REVISIONS			
REV.	DESCRIPTION	DATE	APPROVED
-	INITIAL RELEASE	5/27/05	BC
A	SHEETS 2 AND 3 HAVE BEEN REVISED	4/21/10	TH TGD
B	ADD PULLEY, SEE SHT 2	11/15/12	TH TGD GA
C	PER ECO-0031589: ADD NOTE 2; RENUMBER PARTS LIST; REVISE P2, P3 - AS NOTED ON SHEETS	1/10/2013	TH TGD GA

SIZE <b>B</b>	TITLE ASSEMBLY, 708-1 MAIN	REV <b>C</b>
DATE: 05-27-05   B CHAIDEZ		SHEET 1 OF 3

SIZE	TITLE	REV
B	ASSEMBLY, 708-1 CRANKCASE	C

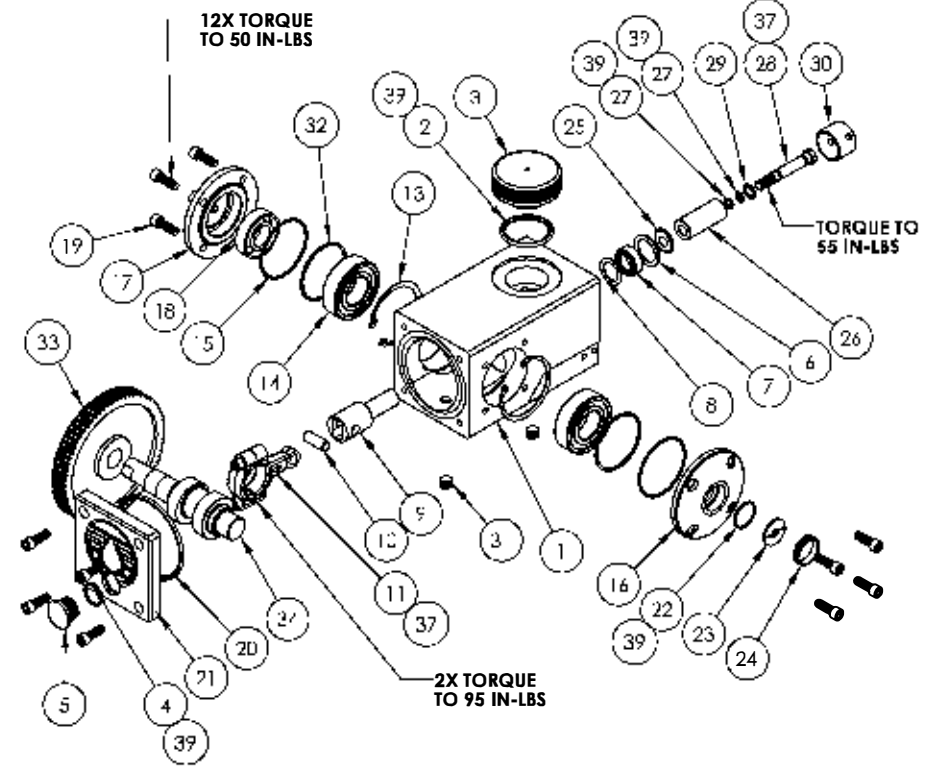
REV.	DESCRIPTION	DATE	APPROVED
-	INITIAL RELEASE	5/26/05	BC
A	MODIFIED QTY TO F. NOT INCL. ICS ITEM. NOT IN P. 151616	3/26/10	CC
B	ADD ITEM 37 & 39 PARTS WAS FOR 37 ADD ITEM 39 CRANKCASE	11/15/12	TH TGD
C	PER ECO-0031589: ADD ITEM 37 - THREAD LOCKER: ADD ITEMS 37 & 39 BALLOONS: ADD: TORQUES	1/10/13	TH TGD GA

SIZE	TITLE	REV
<b>B</b>	ASSEMBLY, 708-1 MANIFOLD	<b>B</b>
DATE: 05-27-05	B CHAIDEZ	SHEET 3 OF 3

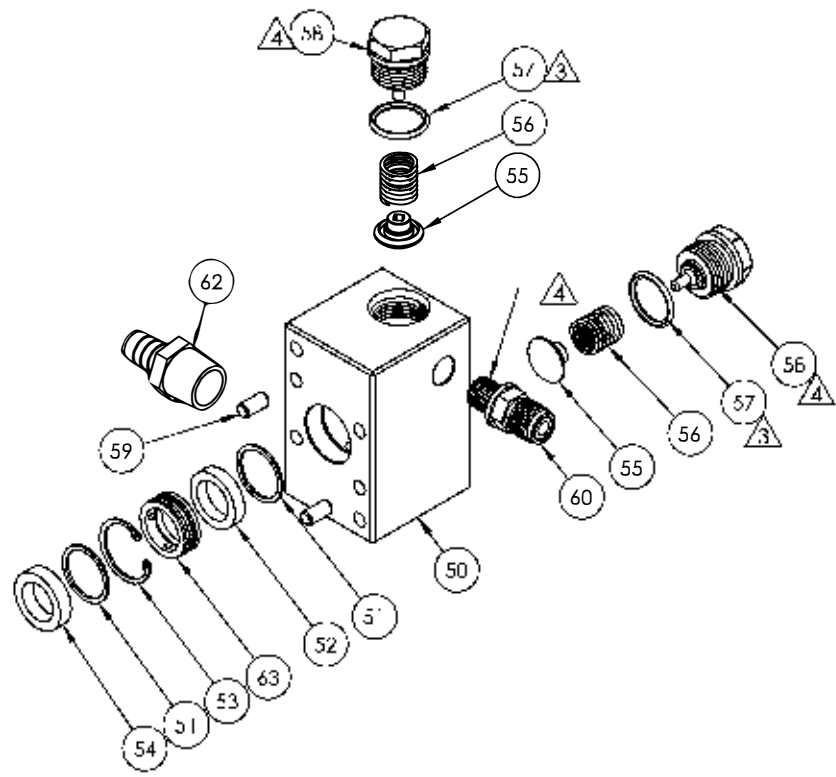
2) ~~PART NO. 8500087 AND 21-0022 ARE NOT SHOWN IN DRAWING.~~

3) APPLY A THIN LAYER OF SILICONE GREASE ITEM 65 (21-0022) TO ALL O-RINGS.

4) APPLY A LAYER OF GRAPHITE ANTISEIZE ITEM 64 (OR P/N 90-0928) TO ALL CONTACT THREADS OF ITEMS 58 & 60 BEFORE MOUNTING.
